U.S. 1 COUNCIL OF PLANNING MEETING Wednesday, March 23, 2016

Agenda

US 1 Council of Planning Pending Development Map

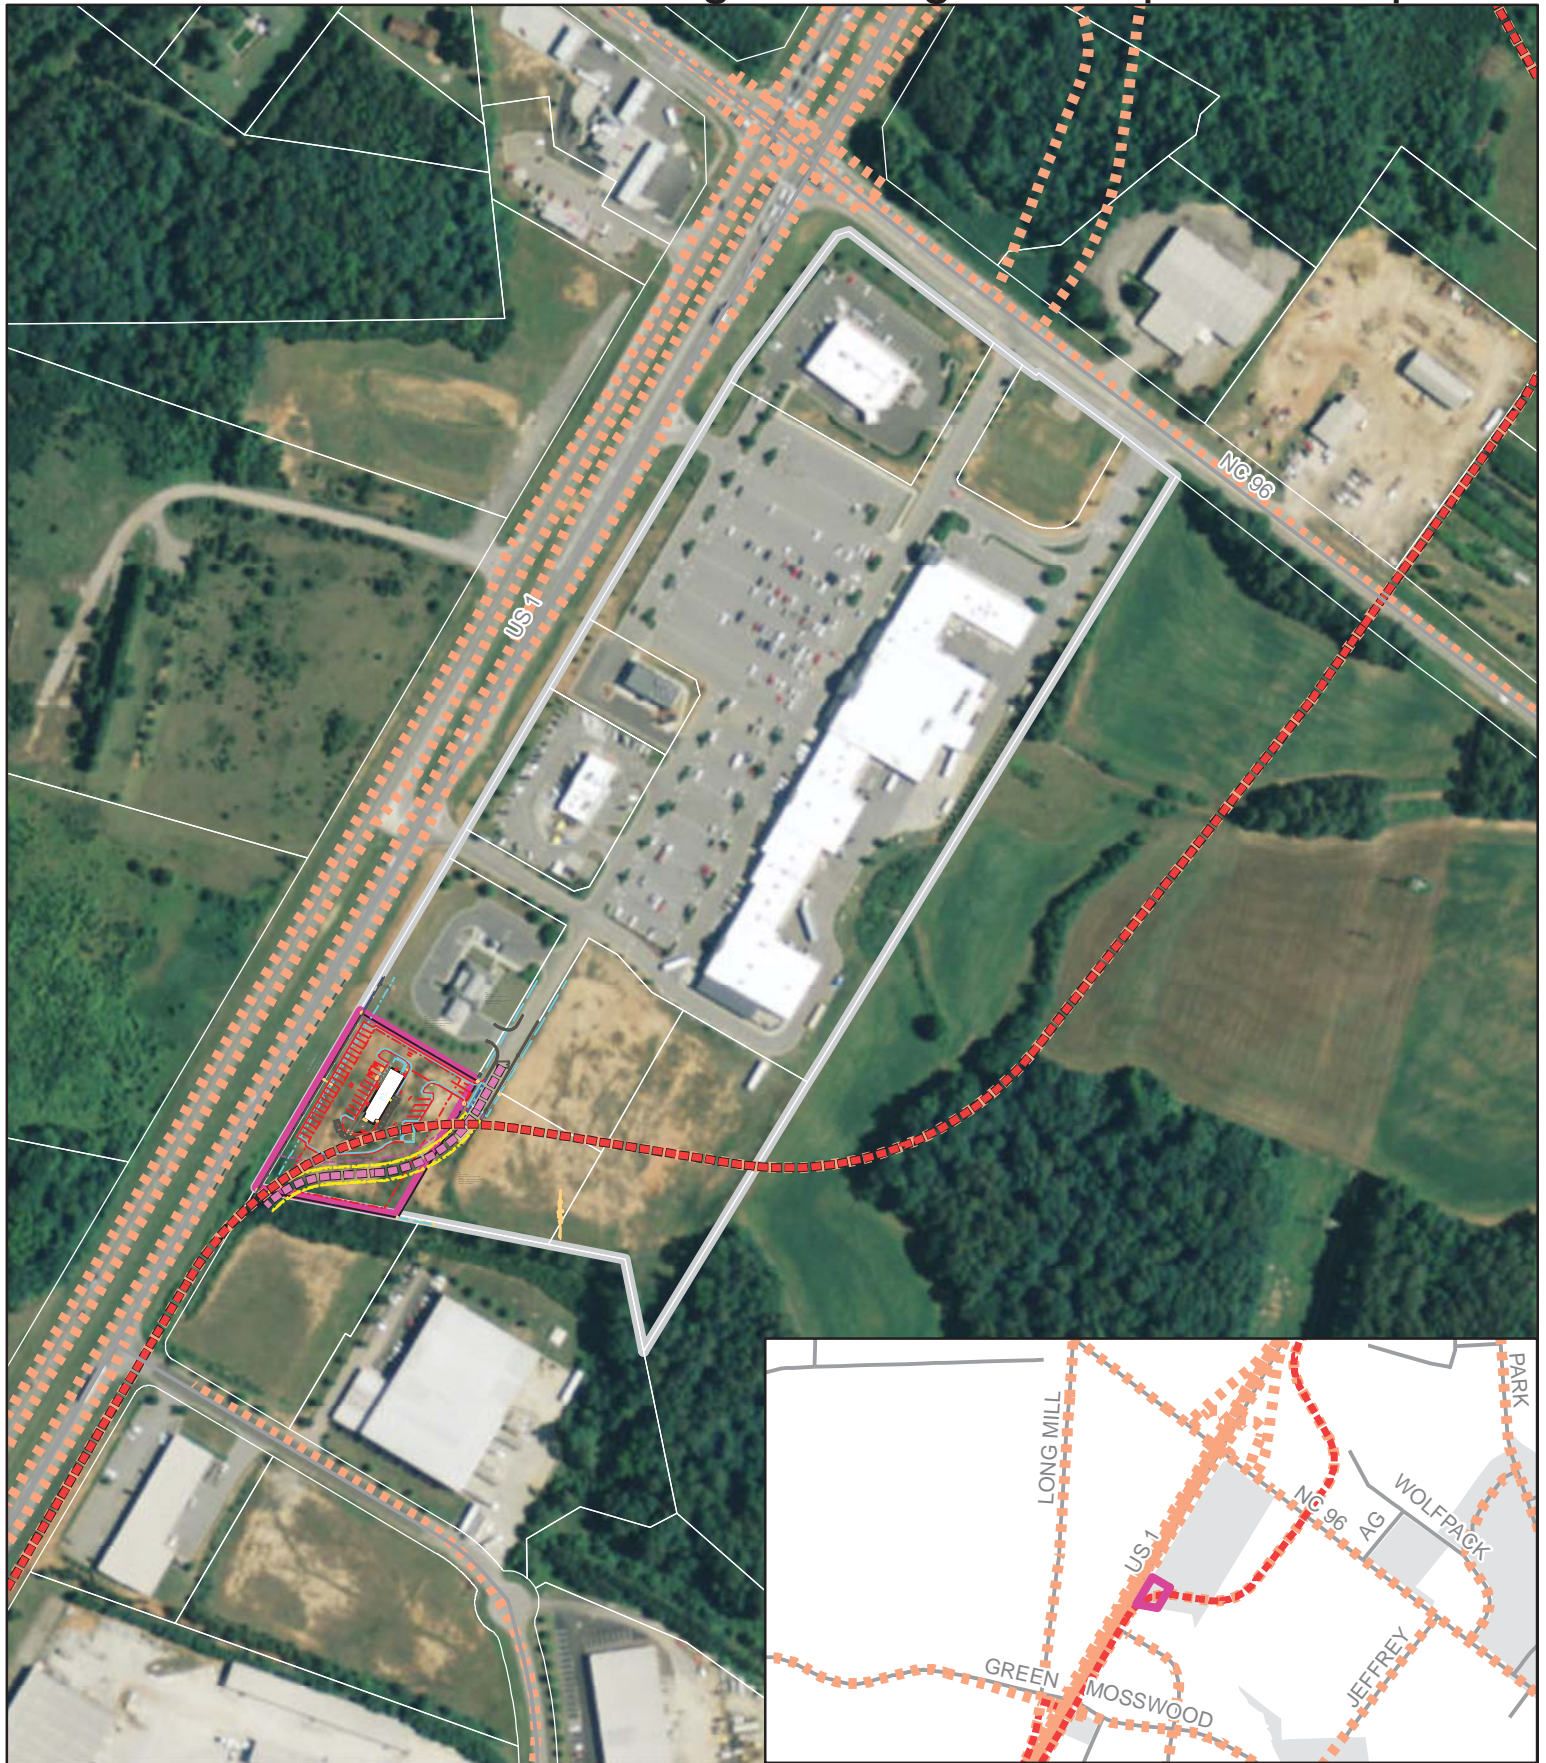
Proposed Taco Bell (SW portion Youngsville Crossing 1/3 mile south of US 1 and NC 96)

- This parcel is already subdivided.
- Per the US-1 Corridor Study, provisions should be made for the extension of the frontage/backage roads around the proposed interchange at US1 and NC 96. The current site plan shows accommodation for the future facility by extending the current access from Youngsville Crossing south.
- **Action:** Discussion and action as necessary
